EH-PLANS-24-0

EnvHealth/Environmental Health/Plan Check/Application

SFD/ INSTALL 22' X 45' 990 SF INGROUND STEEL ENFORCED CONCRETE SWIMMING POOL IN REAR YARD. DEPTH 3'6"-8.0", WITH FENCE TO CODE, FILLED BY TRUCK

**From:** Oswald Jr, Woodin  
**Sent:** Wednesday, March 6, 2024 7:56 AM  
**To:** Beth Galloway  
**Subject:** RE: B24000659  
**Attachments:** as built.pdf

02/21/24  
1:40  
SITE PLAN

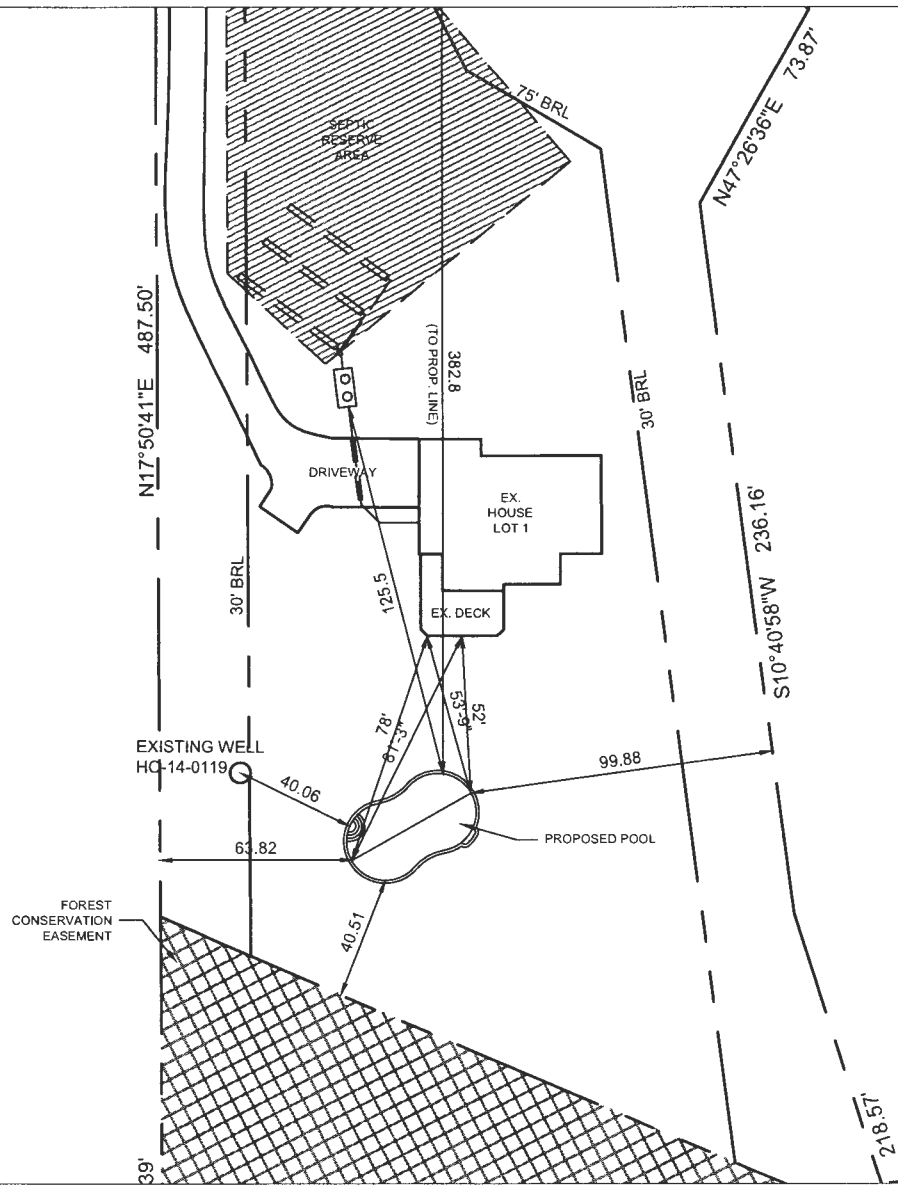
Please revise the site plan to show the correct orientation of the septic tank and SHC (see attached as-built drawing for more details). Also, change the scale to 1:50 which it appears to be anyway. In general, the well and septic program only accepts site plans with the following scale; 1:20, 1:30, 1:40, 1:50, or 1:60 scale.
